DATE: 6-24-16

APPLIES TO: This service bulletin applies to chassis cabs altered between December 17, 2014 and November 12, 2015.

CONDITION: Hadley bulk head frame rail connector interference of fuel line

CORRECTION: Re-locate re-route Hadley bulk head connector

FIG. 2-2

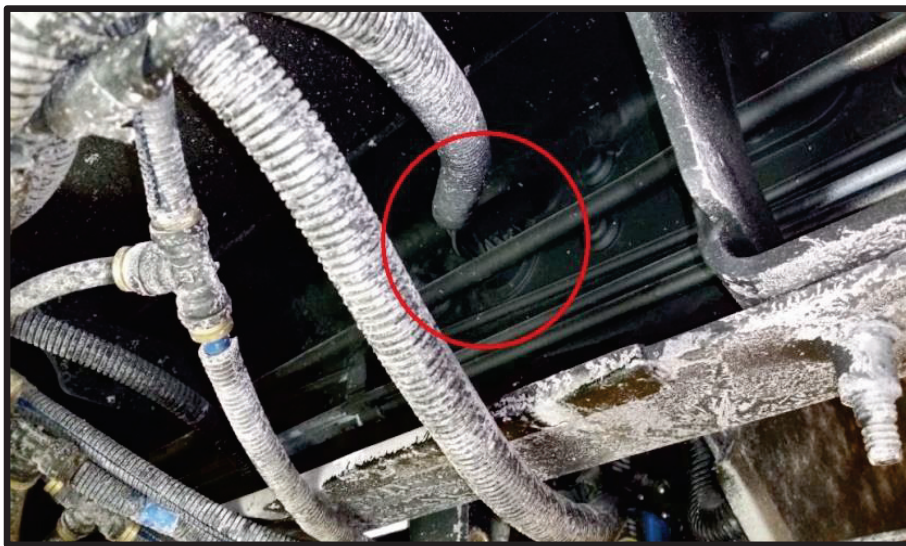
2. Unscrew Hadley connector from frame rail. Refer to FIG. 2-2.

FIG. 3-1

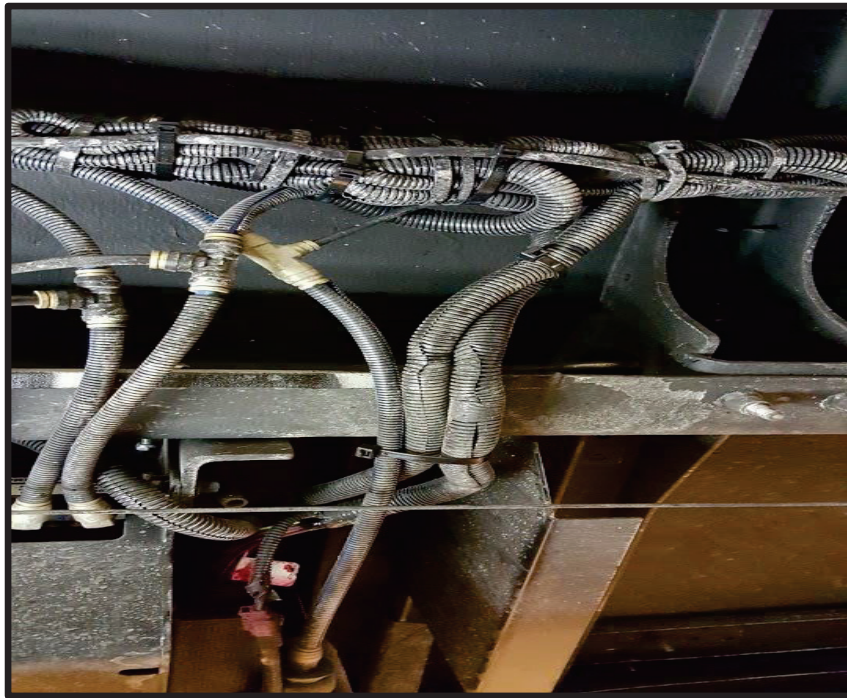
3. Adjust routing to follow FIG. 3-1.
